**GFA AD 469**

## **GFA AIRWORTHINESS DIRECTIVE**

T59 Kestrel all models.

Corrosion of the elevator pushrod in the fin.

## FIGURE 1 PUSHROD END

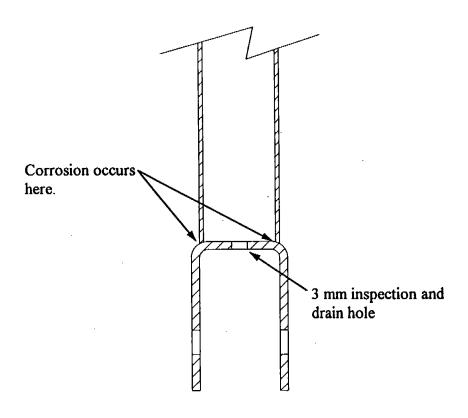
The pushrod should be inspected by removing the rod end (mark the rod end so that it can be reinstalled in the correct place), drilling a 3 mm hole in the bottom of the pushrod (see Figure 1) and shining a light through the hole and inspecting from the other end.

If no corrosion is found a small amount of corrosion inhibiting paint should be poured into the pushrod an sloshed around to evenly coat the interior of the tube and the excess paint drained out. The hole drilled in the bottom of the tube must be left open as a drain hole.
